For Comments against Annex 179C
(Comments #330-344)

Sam Kocsis, Amphenol

November 2024

Proposed Figure 179C-1

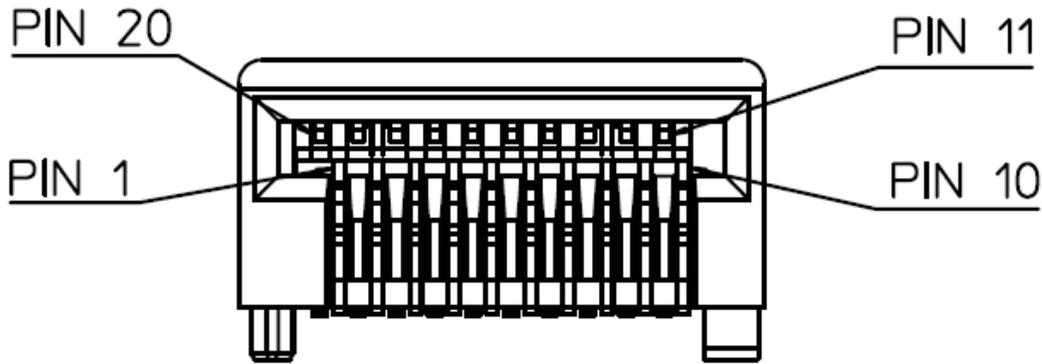
Comments 330, and 331

- For SFP224

Figures same as 802.3ck-2022, Figure 162C-1,2 on pg. 296

Proposed Figure 179C-3

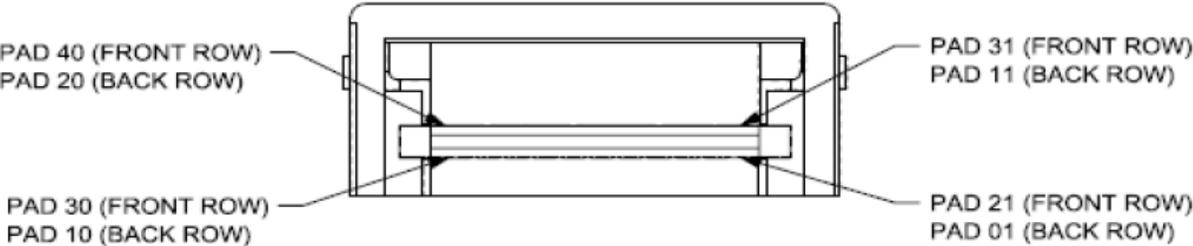
Comments 333, and 334

- SFP-DD224

Figures same as 802.3ck-2022, Figure 162C-3,4 on pg. 297

Proposed Figure 179C-5

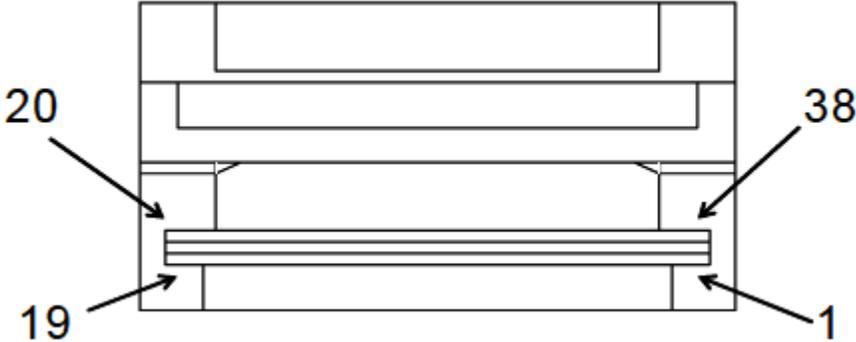
Comments 335, and 336

- QSFP224

Figures same as 802.3ck-2022, Figure 162C-7,8 on pg. 299

Proposed Figure 179C-7

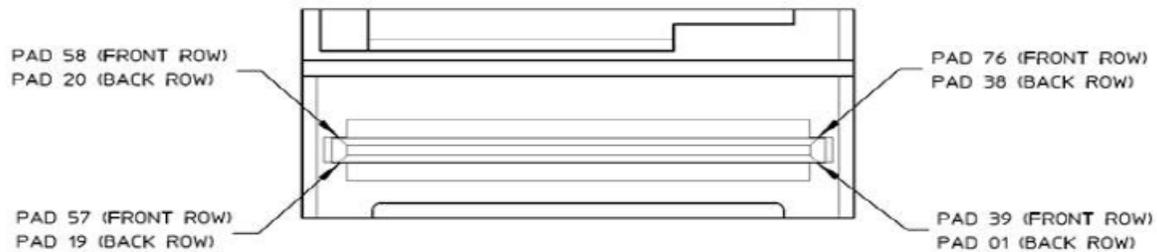
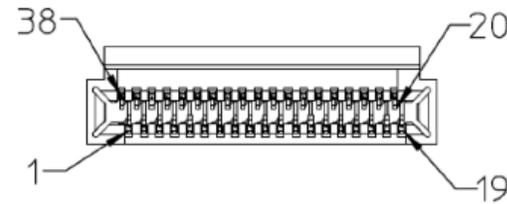
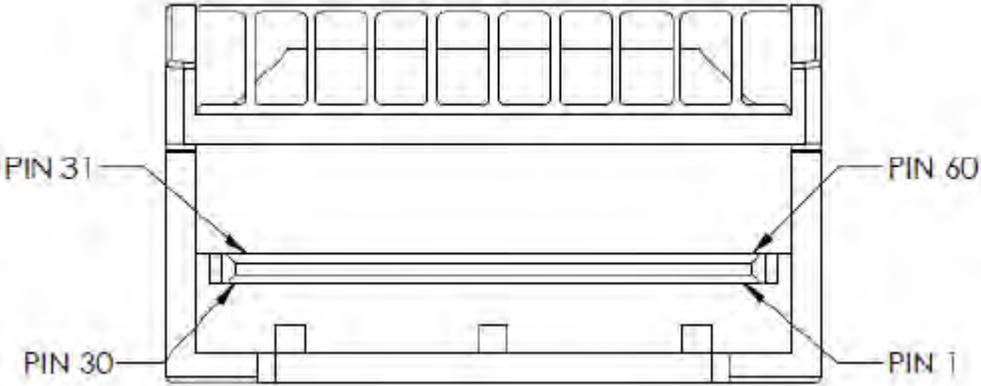
Comments 339, and 340

- QSFP-DD1600

Figures same as 802.3ck-2022, Figure 162C-9,10 on pg. 299/300

Proposed Figure 179C-9

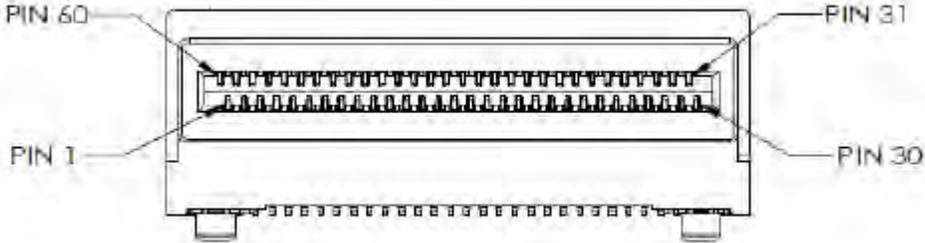
Comments 342, and 343

- OSFP1600

Figures same as 802.3ck-2022, Figure 162C-11,12 on pg. 300/301
